Original	C2PC	Difference Description
		1: adding Reset IC UM404 2: 2.5G ethernet PHY →only four 1G ethernet, so 2.5G ethernet PHY circuits DNP 3: 1G ethernet single port transformer→ without 2.5G ethernet, so this single 1G transformer DNP 4: 5G wifi FEM, brand: Richwave , Model: RTC7676D →Brand: Skyworks , Model: SKY85755-11

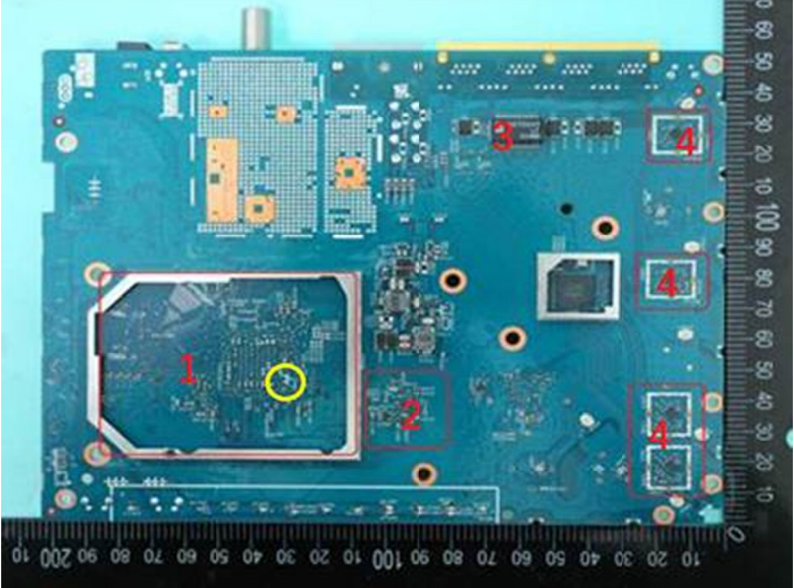
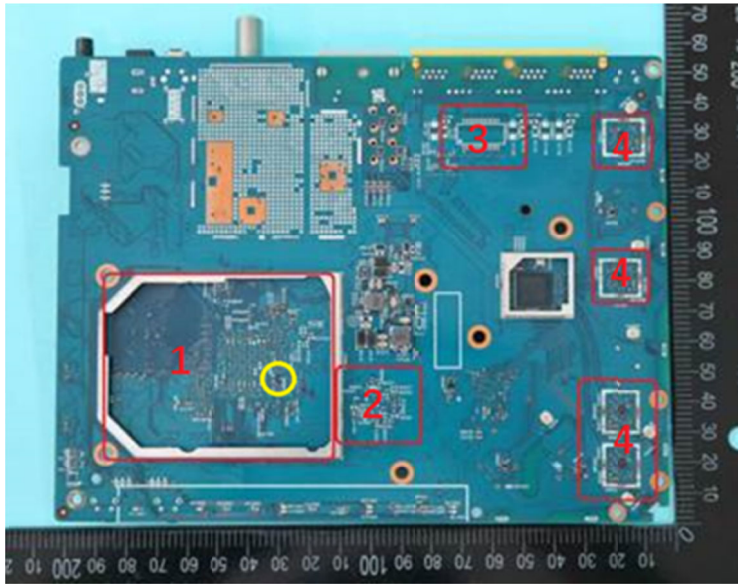
1: adding Reset IC
UM404
6: HWID different:
2.5G Ethernet →
without 2.5G
ethernet

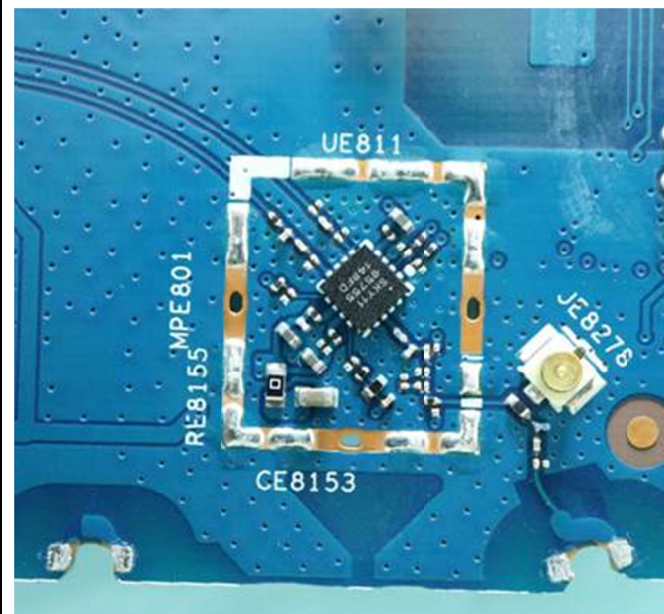
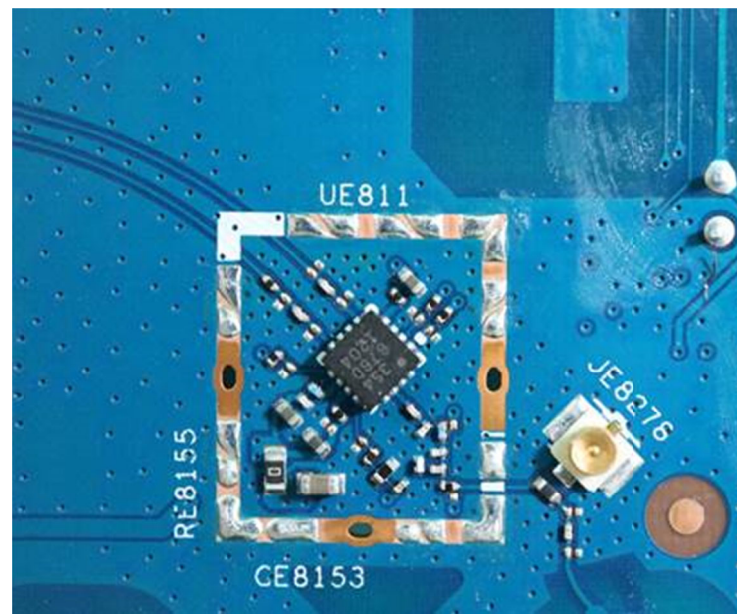
2: 2.5G ethernet
PHY : 2.5G ethernet,
so 2.5G ethernet PHY
circuit populate.→
only four 1G
ethernet, so 2.5G
ethernet PHY circuits
DNP

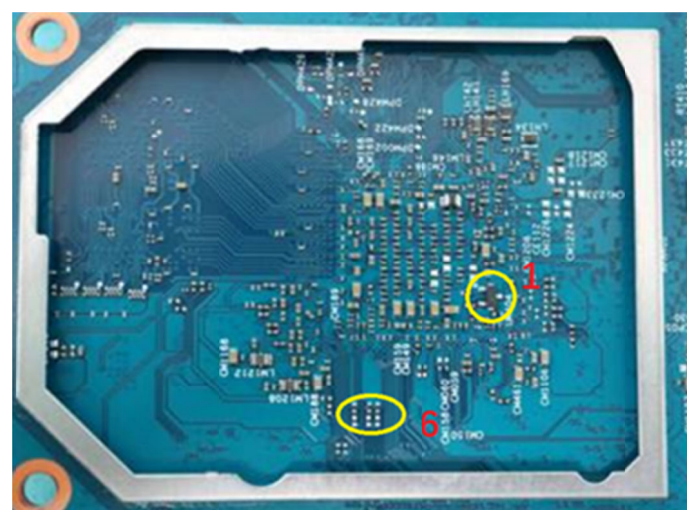
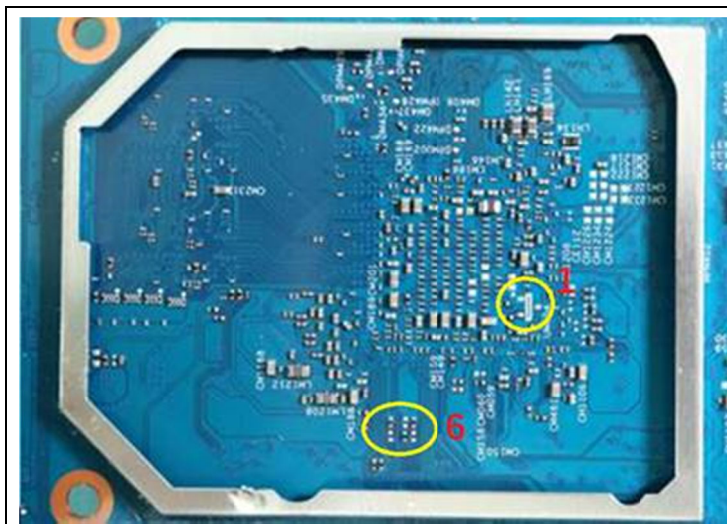
5: 2.5G ethernet
transformer:
2.5G ethernet, so
single 2.5G
transformer
populated→
only four 1G
ethernets, so two
dual port
transformer
populated.

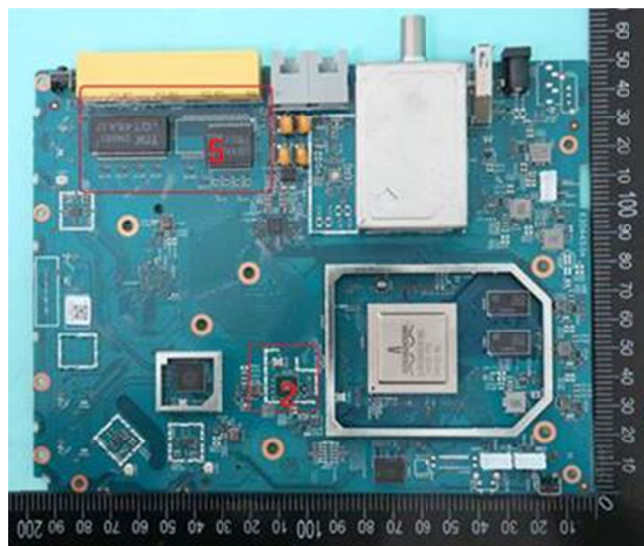
Refer description 4.
